SAN JACINTO RIVER COALITION

RE: Comments on Army Corps of Engineers August 2015 Draft Final Evaluation of SJWP FS Remedial Alternatives

Figure 1.

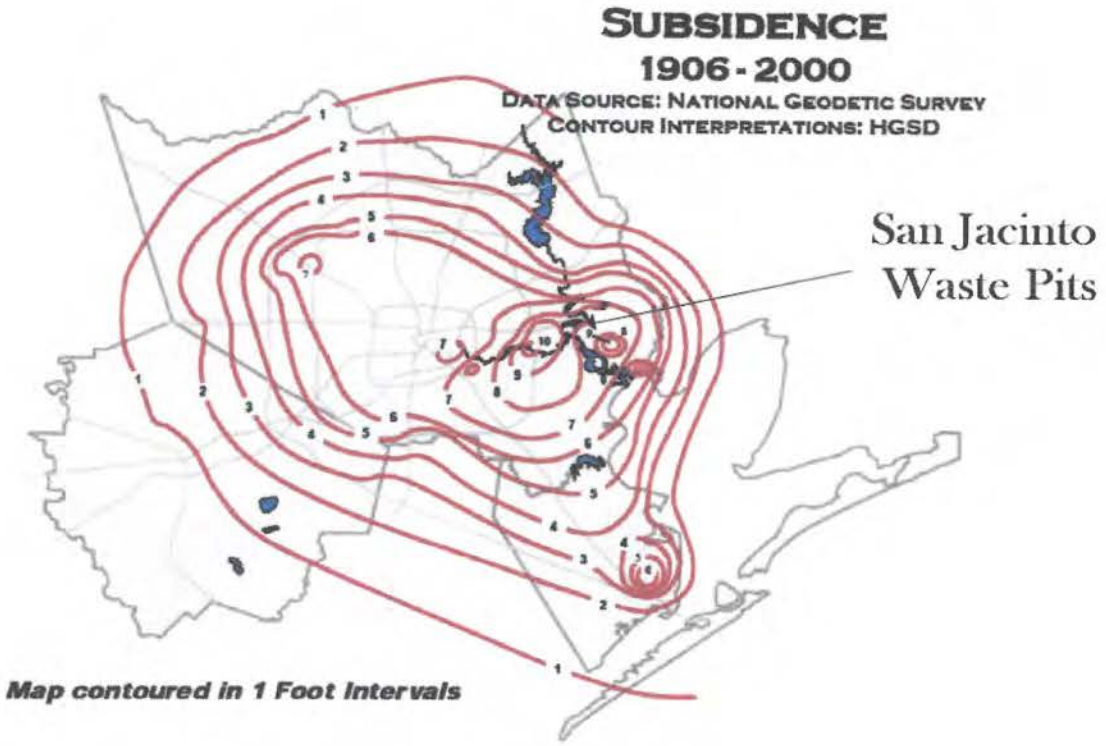
Admittedly, subsidence has effected the Waste Pits in the past, and we cannot know for certain how much the land will subside in the future. What we do know for certain is that local populations and industrial businesses continue to grow which leads to increased extraction of groundwater. Most municipalities use a minimum of 20% groundwater and there are over 1,000 privately owned groundwater wells within five miles of the Waste Pits. See Figures 1 & 2.
